CAIRNGORMS NATIONAL PARK AUTHORITY

Title: REPORT ON CALLED-IN PLANNING APPLICATION

DEVELOPMENT PROPOSED: OUTLINE PLANNING PERMISSION FOR ERECTION OF 6 FLATS AND 4 DWELLINGHOUSES & LISTED BUILDING CONSENT FOR DEMOLITION OF FLAT ROOFED EXTENSION, SITE AT REAR OF GRANT ARMS HOTEL, THE SQUARE, GRANTOWN-ON-SPEY

REFERENCE: 06/304/CP & 06/305/CP

Fig. 6. Indicative Site Layout and Elevation for Terrace of 4 Houses

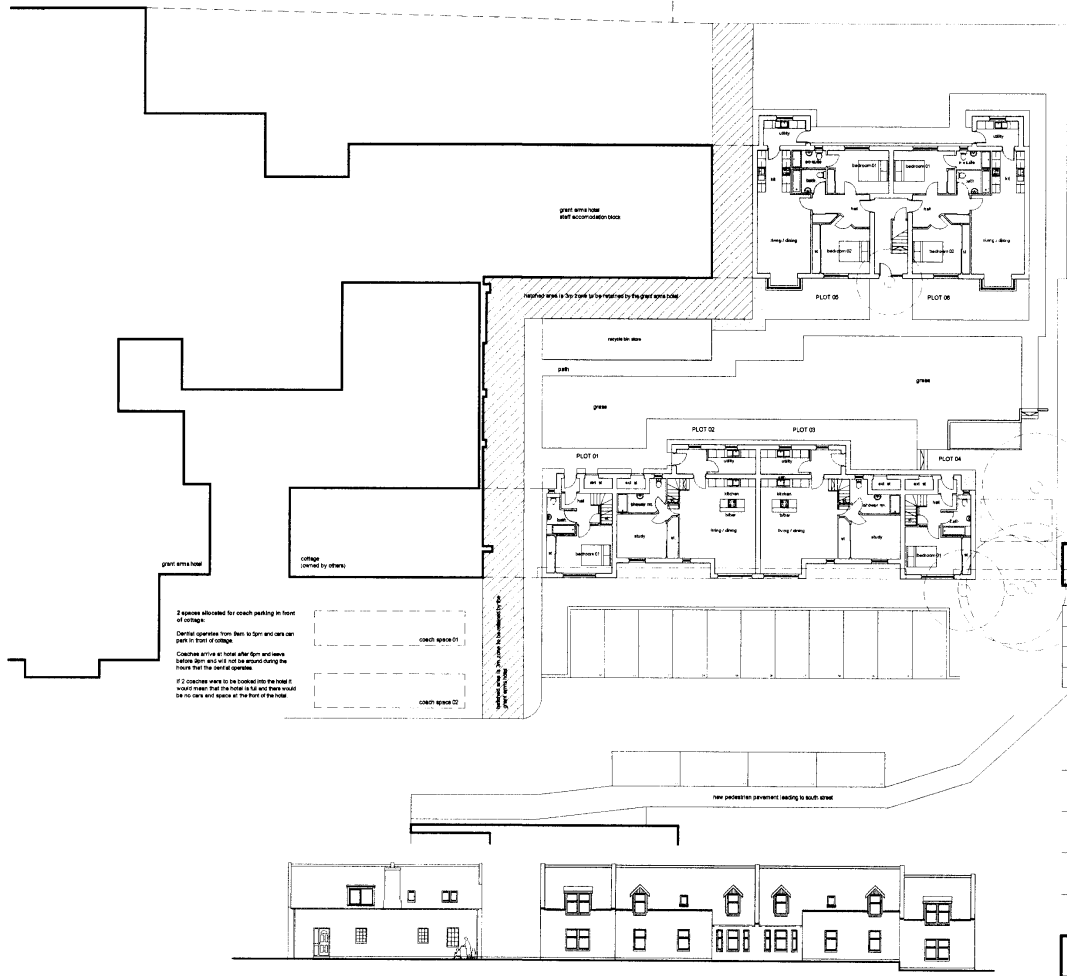
34. Concerns have been raised in terms of the amount of development proposed for the site, from various consultees, including Highland Councils Planning and Roads Services. In my view, the existence of the large hotel extension wing to the rear of the hotel and adjacent to the site, provides an imposing, overbearing, and inappropriate scale and design of development for this Conservation Area site, within the grounds of a Listed Building, and in relation to surrounding properties. While limited views from the Square are achievable, it can be seen from other areas. The proposed flatted block is indicated as lower than this extension, but I do not feel it is appropriate to accentuate this overbearing scale or form of development in the location proposed. The flatted block remains of a significant scale and height (12m), in

relation to its neighbours to the north and east. It will be positioned, at its least 6.8m, and at its most 8.8m, from the north boundary where the adjacent building is a one and a half storey residential unit ("Salmornish") with rear garden. The indicative north elevation shows windows serving habitable accommodation which will overlook this boundary. On its east side, the two and three quarter storey gable of the flatted block will sit less than 3m from the mutual boundary with the 2 storey residential properties on this side ("Strathspey Lodges"). These properties are also at a lower level to the proposed site. It is also the case that the hotel extension has windows on its east gable which will be 3m from the blank west gable of the proposed flatted block. Since the proposed building lies in such close proximity to its site boundaries and its adjacent properties, my view is that this block, being of the size and scale indicated, would have an unacceptably high overbearing and impact on the area and the Conservation Area in general.

35. The indicative terraced block of 4 houses, aligning with the existing cottage, does represent, in my view, and in the view of the consultees, a more appropriate scale and form of development for this site, in terms of design. However, the amount, quality and potential use of the space between this block and the flatted block is considered to be less than satisfactory. While proposed as a communal grassed area, being limited in depth and configuration, and being "sandwiched between the two blocks and overlooked by the windows on the south elevation of the hotel extension, it does not provide an area where any degree of privacy, ownership or functionality as a useful open space area, can be achieved (policy guidelines do set out requirements for private space provision, in particular for houses). Indeed, users of the communal area would be very close to windows of both the flats and the houses.

46. **As such, I cannot support the proposal for the reasons stated below. In my view a much reduced scheme, addressing the number of units proposed, scale and size of buildings, tree retention, adequate provision of amenity space, and including adequate provision of access, parking and turning space for the hotel, the dental surgery and the residential development, could be achievable. On the basis of the submissions though, the recommendation is one of refusal.**
